DEPARTMENT OF HAWAIIAN HOME LANDS
STATE OF HAWAII

ADDENDUM NO. 2

**PAPAKOLEA SUBDIVISION SEWER IMPROVEMENTS
SEWER LINES E, F, L, A, C, D AND K-3 IMPROVEMENTS**

IFB-17-HHL-010

**SEWER LINE L
PLAN AND PROFILE - 2
& SEWER LINE C PROFILE**

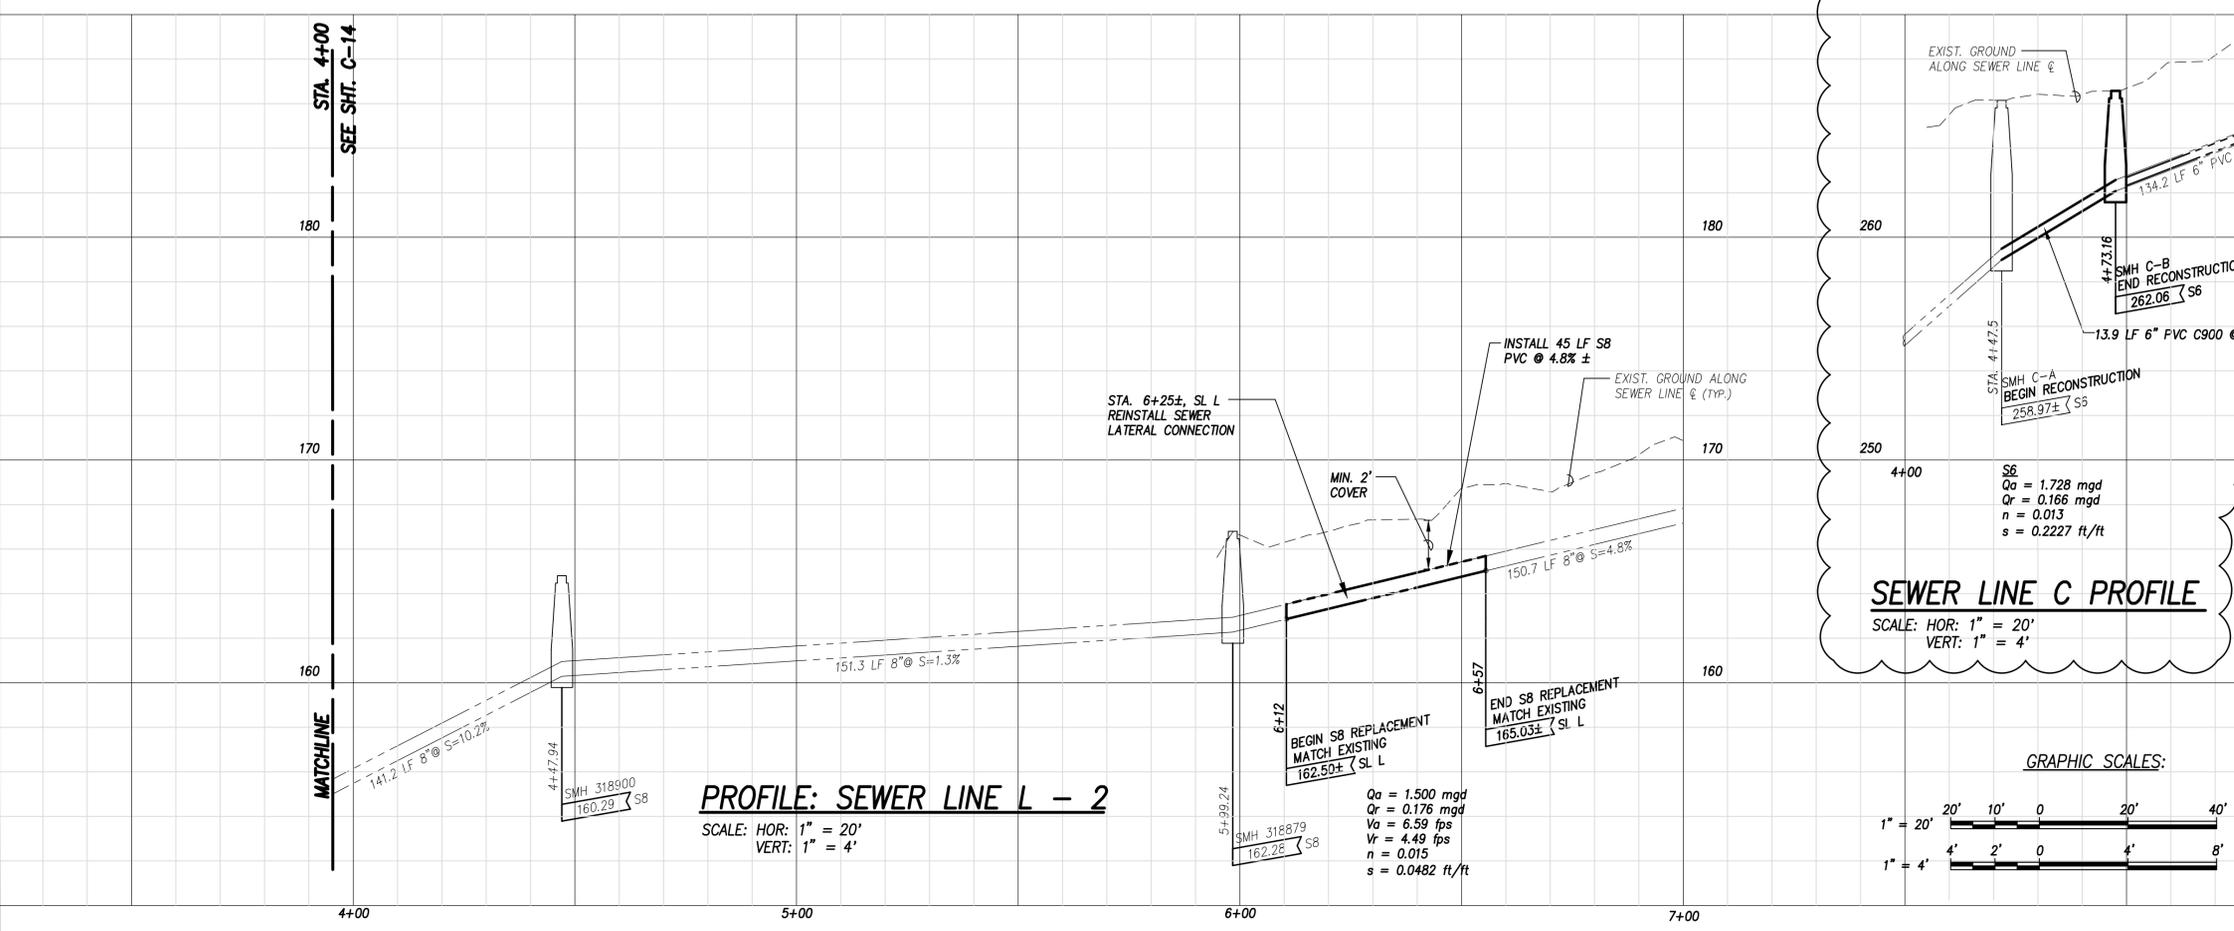
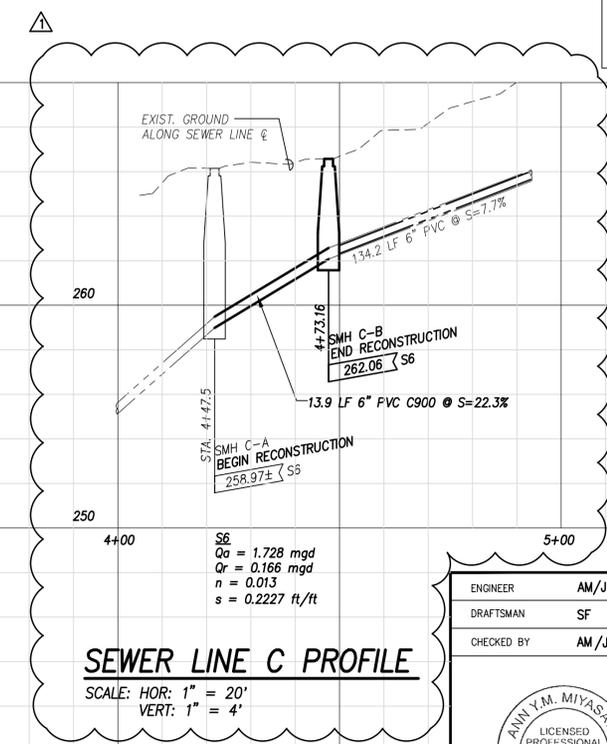
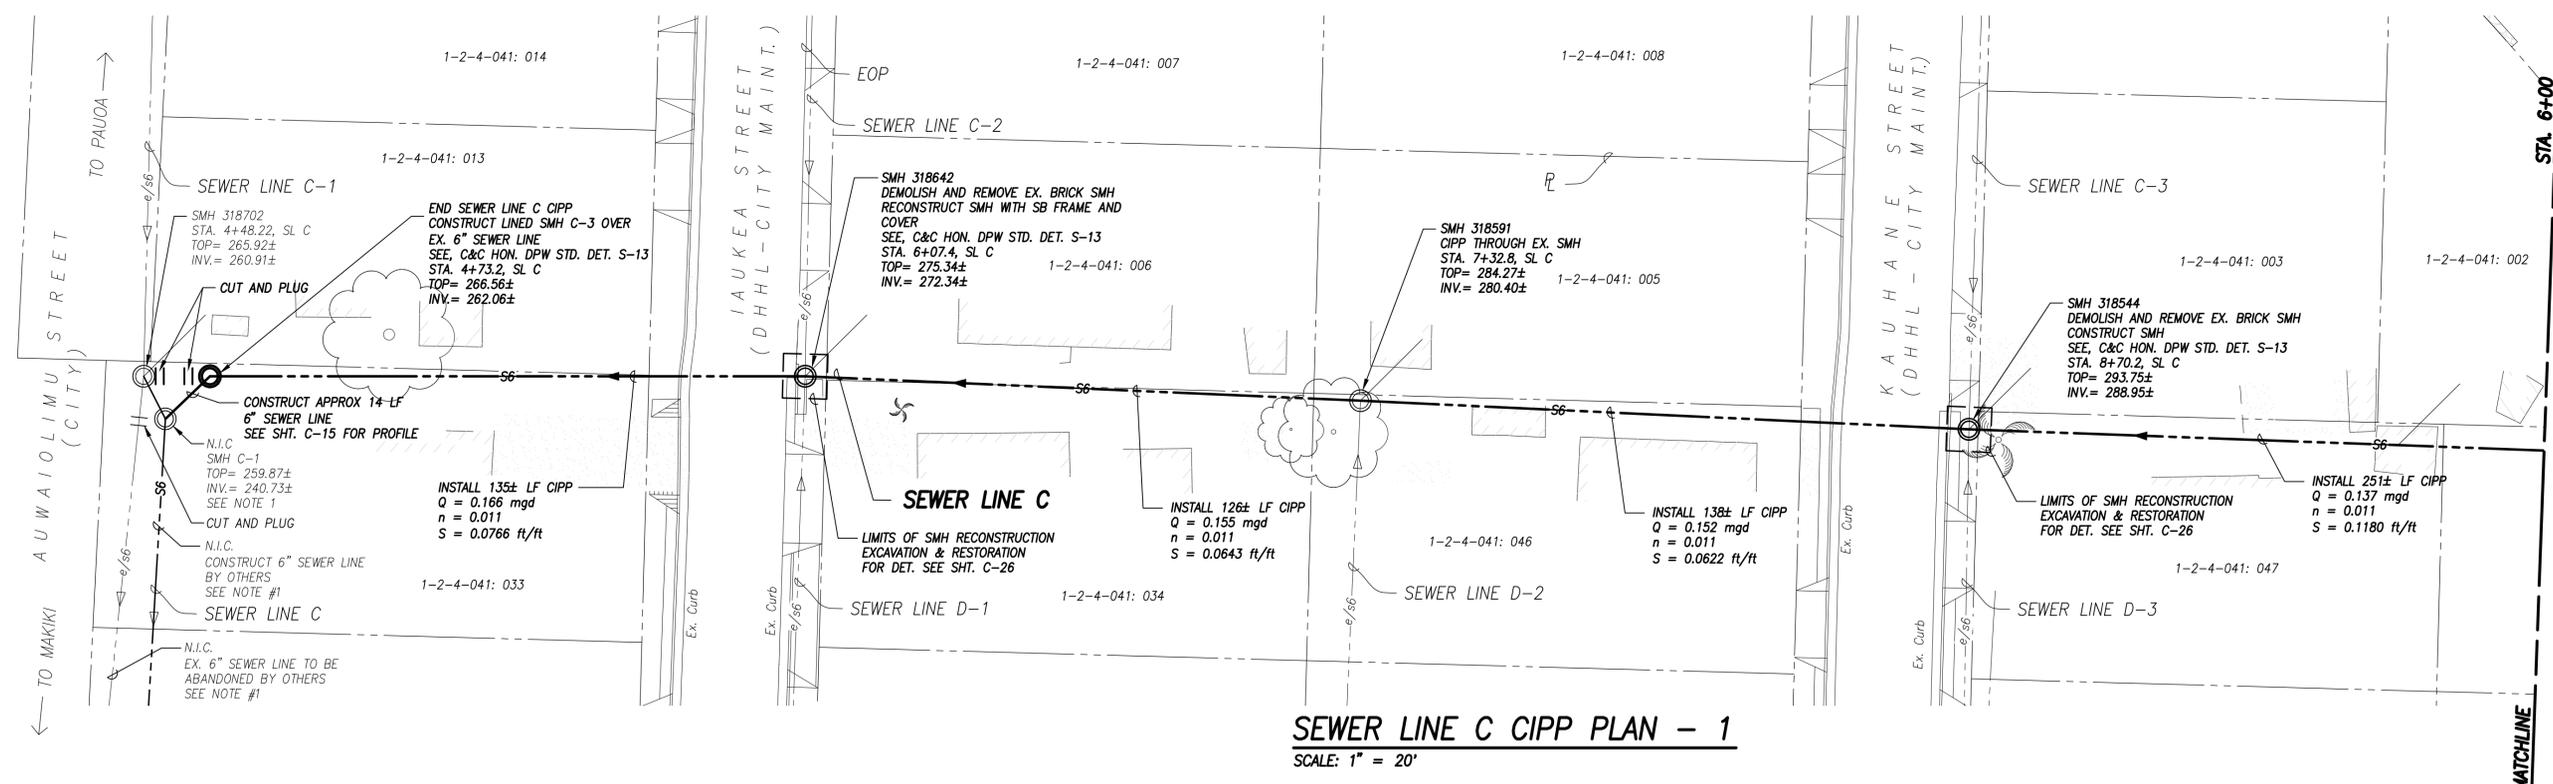
- a. Added Sewer Line C Profile
 - b. Revised title
5. Sheet C-16 – “Sewer Line L Plan - 3”
Sewer Line L, SMH 318811 to SMH 318765, to be rehabilitated by CIPP instead of replaced.

REVISION	DATE	BRIEF	BY	APPROVED
3/27/17	ADD 2: SL C PROFILE, REVISE TITLE	AM	DHHL

SEWER LINE C CIPP PLAN - 1 & 2

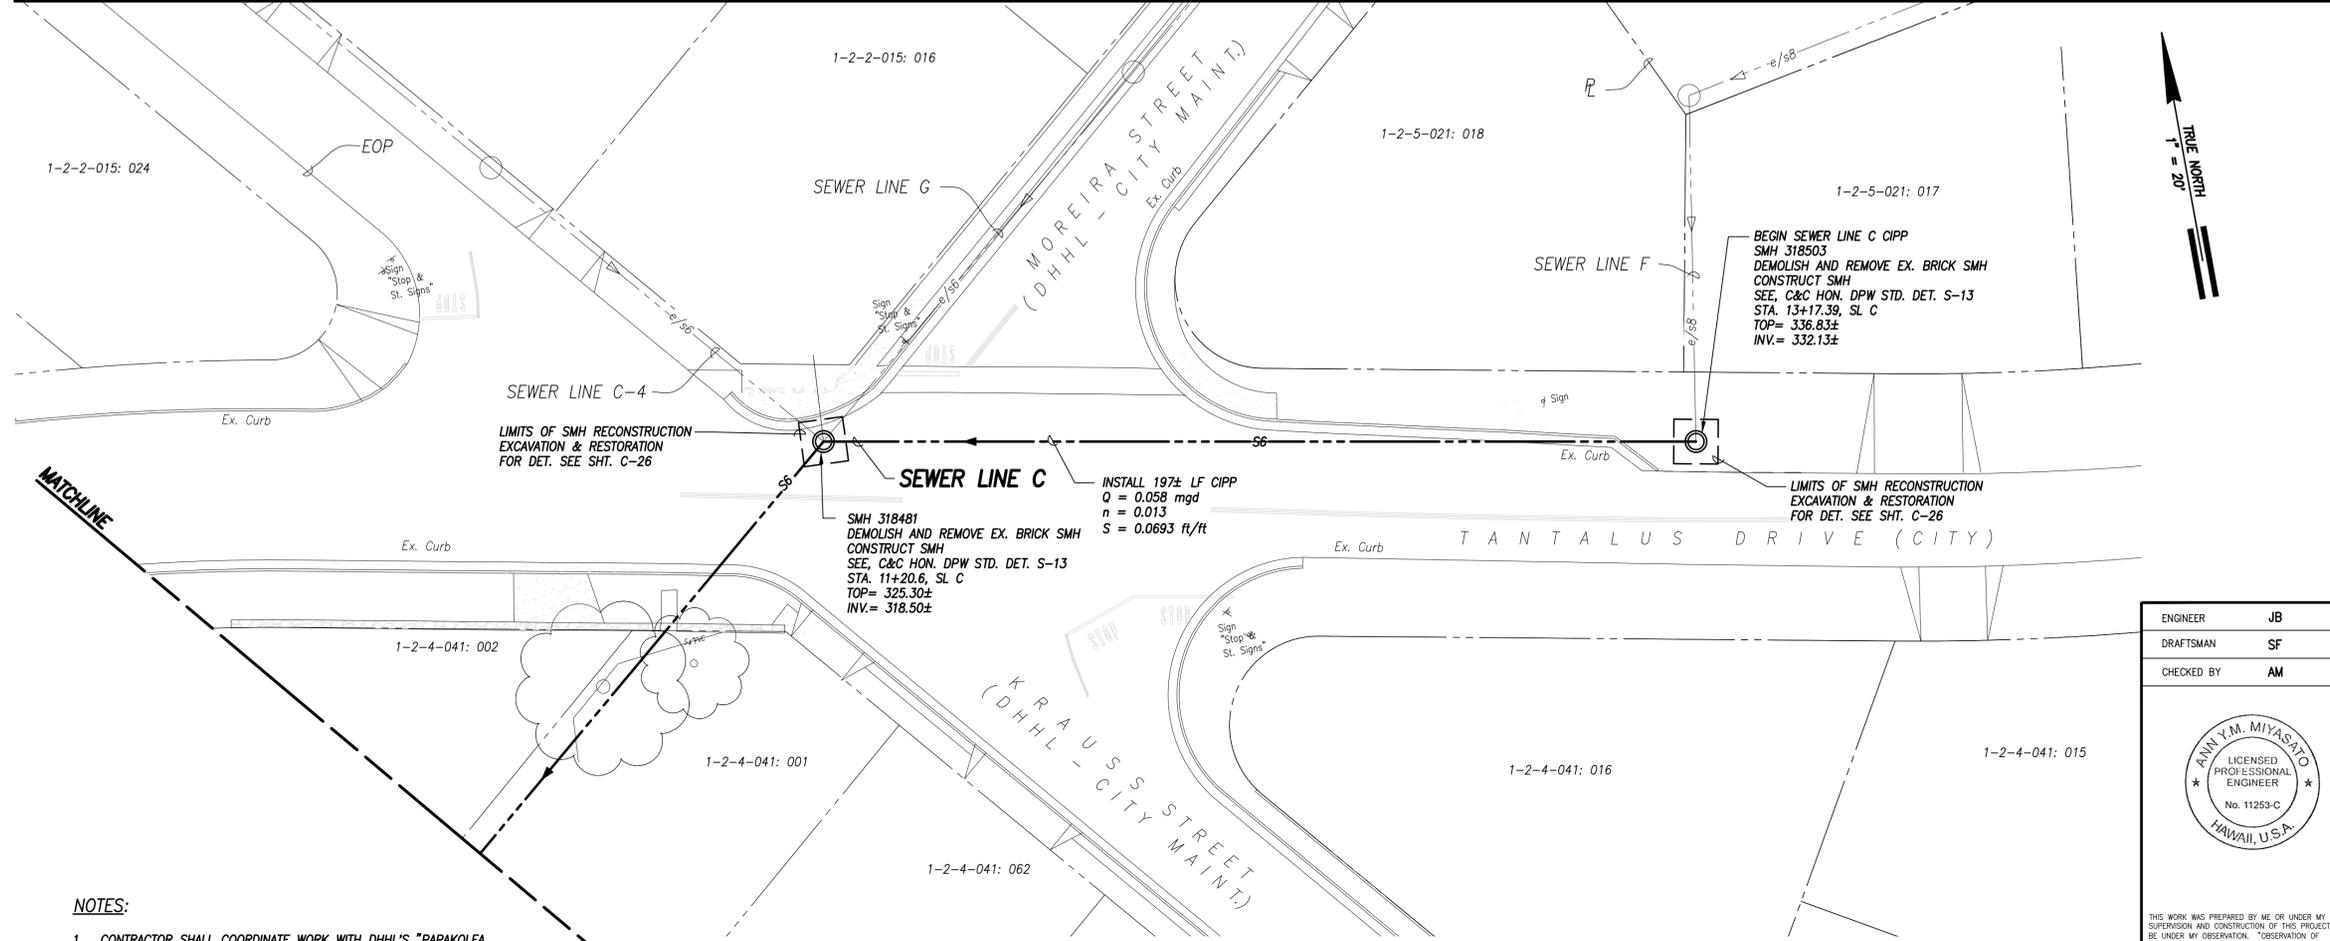
6. Sheet C-18 – “Sewer Line C CIPP Plans - 1 & 2”
Clarified locations of existing curbs, striping, and signage.
7. Sheet C-19 – “Sewer Line D CIPP Plans - 1 & 2”
Clarified locations of existing curbs, striping, and signage.

SEWER LINE K-3 CIPP PLAN

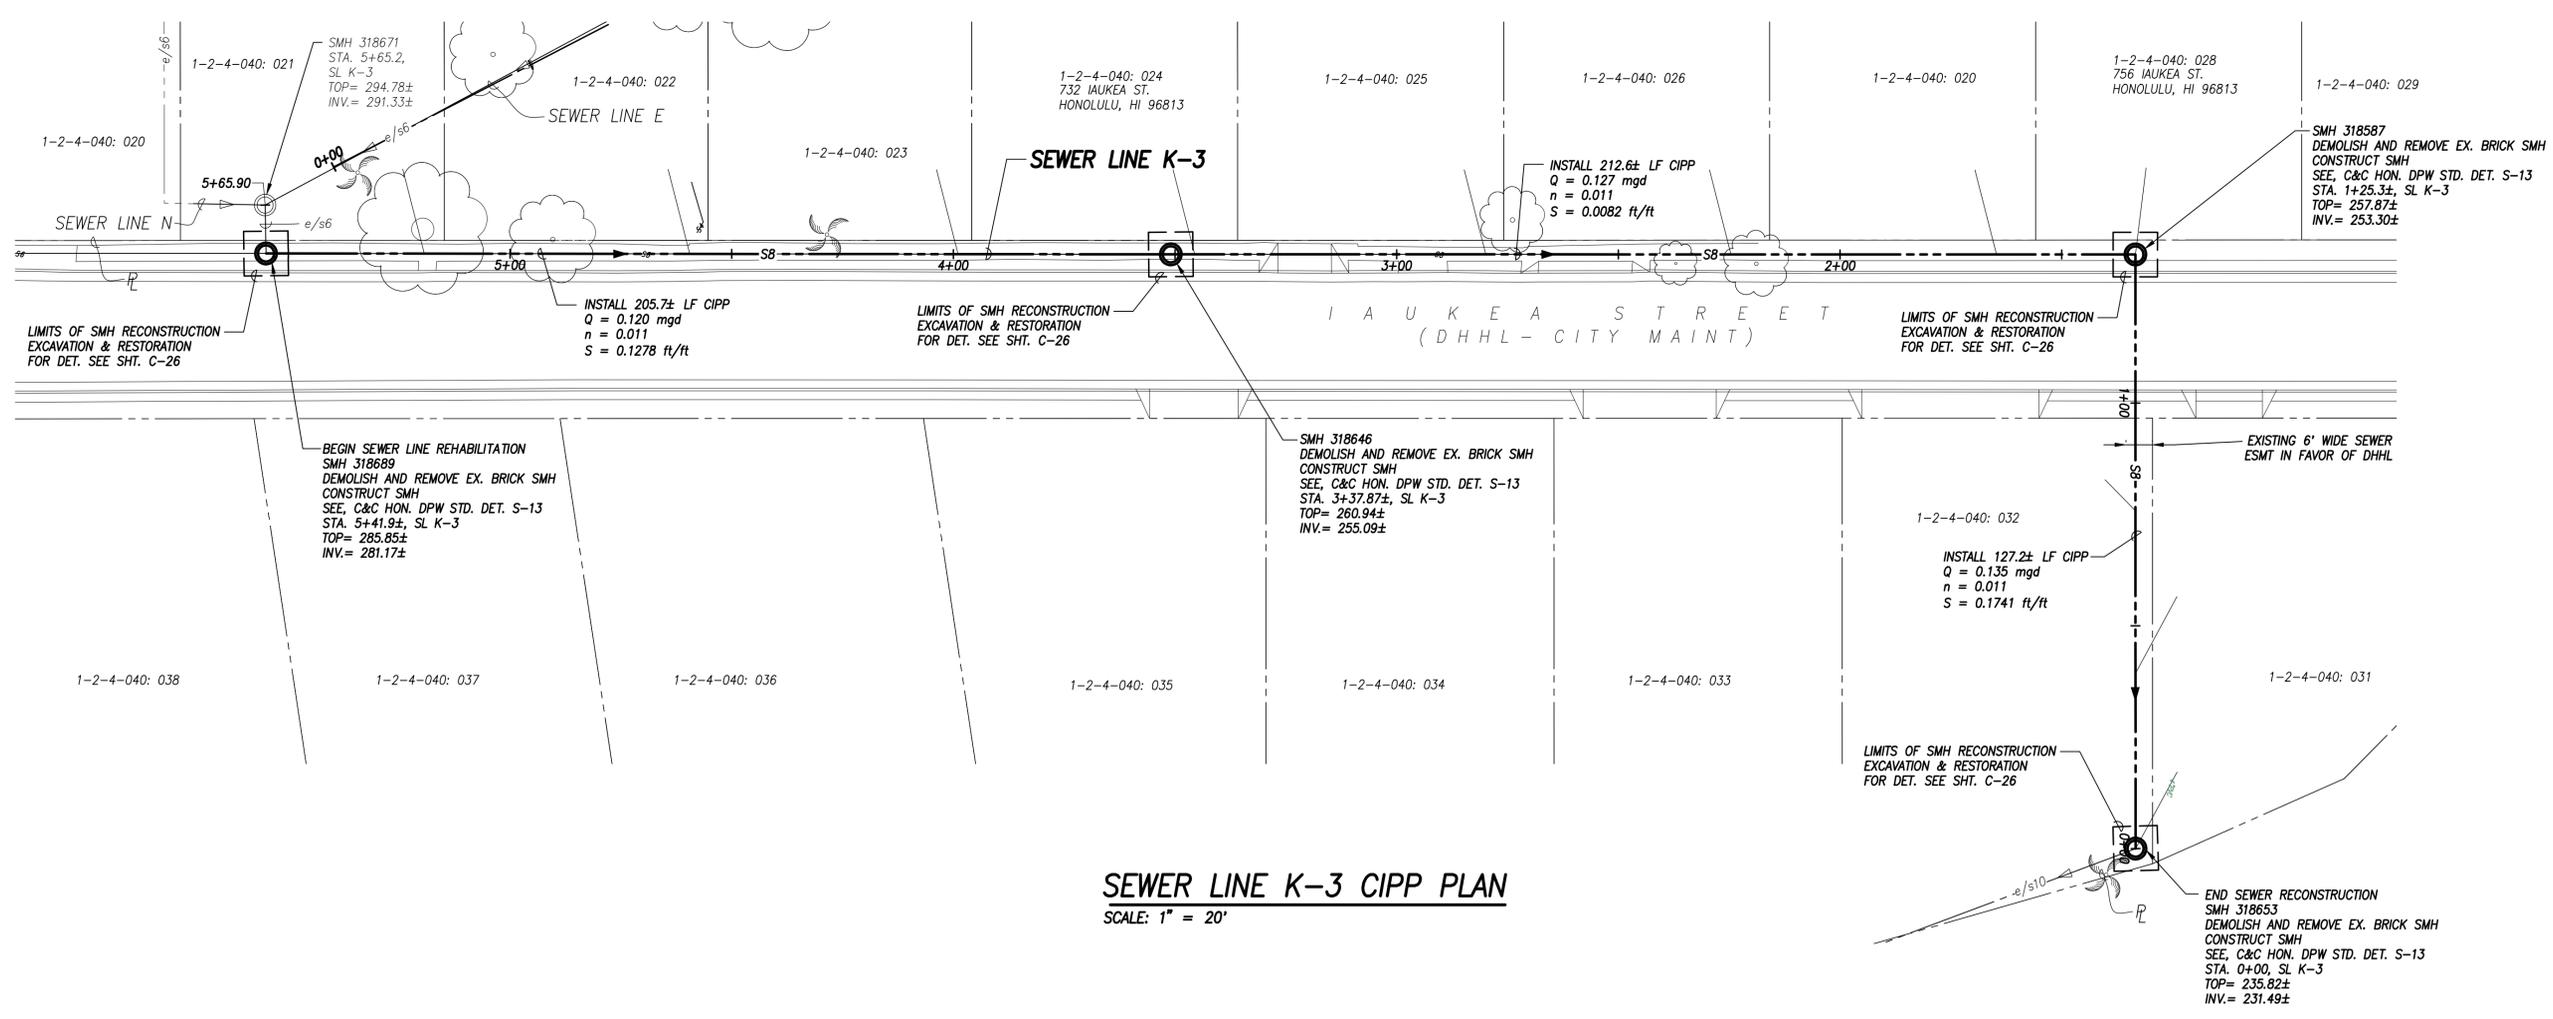
8. Sheet C-20 – “Sewer Line K-3 CIPP Plan”
Clarified locations of existing curbs, striping, and signage.
9. Sheet C-25 – “Sections - 2 & Sewer Line L Grading Plan”
Removed cross sections for Sta. 14+75 and Sta. 15+00. No grading in this area.

SECTIONS - 2
& SEWER LINE L GRADING PLAN

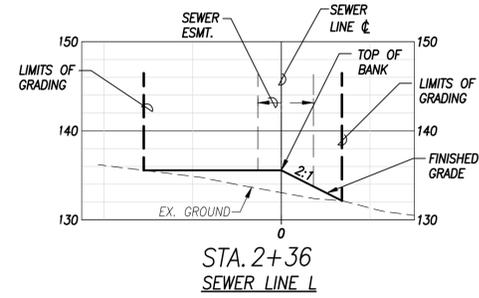
4. **There is grading work shown on the cross section for Sta. 14+75 and Sta. 15+00 for the sewer line F on Dwg C-25, but it is not called out on the profile drawings on Dwg C-12 nor the enlarged grading plans. Please confirm if there is grading work at those stations.**

Answer: No grading in this area.

ENGINEER	AM/SM	REVISION	DATE	ADD 2: REMOVE SECTIONS	AM	APPROVED
DRAFTSMAN	SF	3/27/17			AM	DHLL
CHECKED BY	AM/JN
